# There are no more three bolt Valley cushions

55 years of Valley Cushion history from top to bottom

- Valley 3-bolt Side Rail from early 1970s – 1999
- Valley 3-bolt Side Rail from 1999 - 2009
- Valley 5-bolt Side Rail from 2009 - present

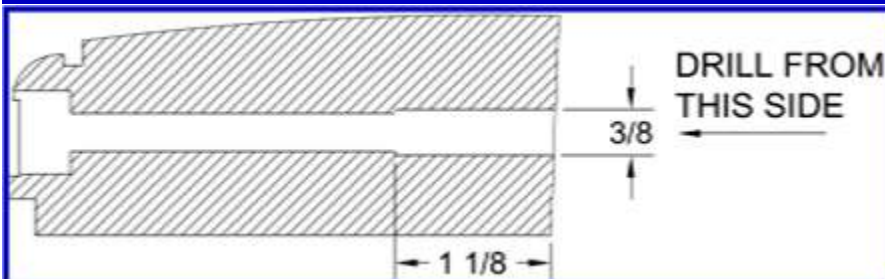
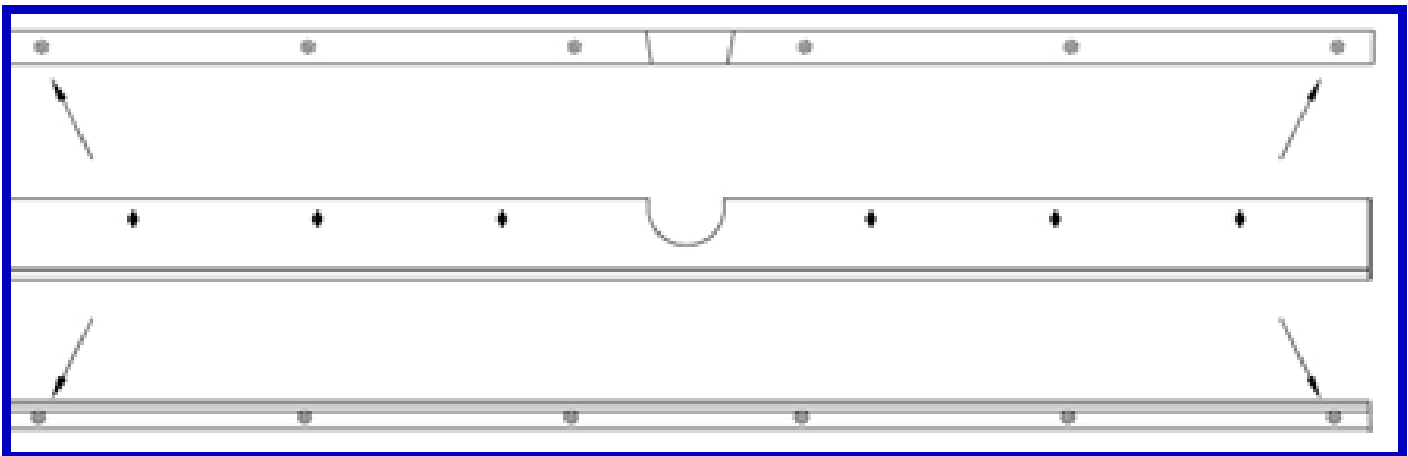
**FIRST BIG THING:** when we went from 3 bolts to 5, we simply added two attachment points to each rail. If you used the older 3-bolt rails – **THE HOLES THAT MATTER TO YOU DID NOT CHANGE**

**SECOND BIG THING:** the change in 1999 moved 4 of the 18 bolt holes used to attach the rails by exactly  $\frac{1}{8}$ ". THAT is the difference between "old Valley" and "new Valley" –  $\frac{1}{8}$ ". Literally so close it wasn't physically possible to put in two inserts side-by-side. **FOURTEEN OF THE EIGHTEEN HOLES DID NOT CHANGE.**

**HOW DO I USE THE CURRENT RAILS ON A VALLEY TABLE MORE THAN 25 YEARS OLD?** On the four side rail bolt holes noted below...

Drill using a  $\frac{3}{8}$ " diameter drill bit. From the cushion side, drill no deeper than  $1 \frac{1}{8}$ ". This allows just enough movement of the rail bolt so it can be angled to attach securely  
End rails *need no modifications*
